Work Order ID 62012

DART

DESIGN <i>PH</i>	DRAWN BY <i>B</i>	DART AEROSPACE LTD HAWKESBURY, ONTARIO, CANADA	
CHECKED <i>PH</i>	APPROVED <i>B</i>	DRAWING NO. D3303	REV. B SHEET 1 OF 4
DATE 06.08.17		TITLE HEAD REST	SCALE 1:3
REV	DATE	DESCRIPTION	
A	04.08.18	NEW ISSUE	
B	06.08.17	UPDATED FLAT PATTERN TO FORM PART IN ONE OPERATION USING OFFSET DIE

DRAWING NO. D3303	TITLE HEAD REST	REV. B	DART AEROSPACE LTD ENGINEERING ORDER		D.E.O. NO. D3303-B-1	SHEET NO. SHEET 1 OF 1	SCALE NTS
DRAWN AJS	CHECKED <i>L</i>	MFG. APPR. <i>AA</i>	APPROVED <i>AA</i>	DE APPR. <i>AA</i>			
DATE 08.10.15	DATE <i>08.10.15</i>	DATE <i>08/10/16</i>	DATE <i>08/10/16</i>	DATE <i>08/10/16</i>

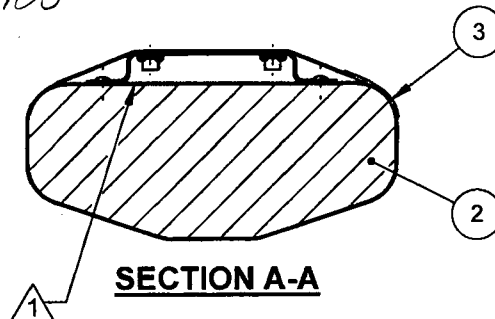
SHEET 1 ADD 1300L ADHESIVE BY 3M TO NOTE 1 AS FOLLOWS:

WAS:

- 1) BOND D3305-1 FOAM TO D3303-043 BRACKET ASSEMBLY USING 3M 1300 ADHESIVE (0.002" TO 0.010" THICK) IN ACCORDANCE WITH MANUFACTURER'S INSTRUCTIONS

IS:

- 1) BOND D3305-1 FOAM TO D3303-043 BRACKET ASSEMBLY USING 3M 1300 OR 1300L ADHESIVE (0.002" TO 0.010" THICK) IN ACCORDANCE WITH MANUFACTURER'S INSTRUCTIONS

SEE NCR 08-069 FOR FURTHER DETAILS
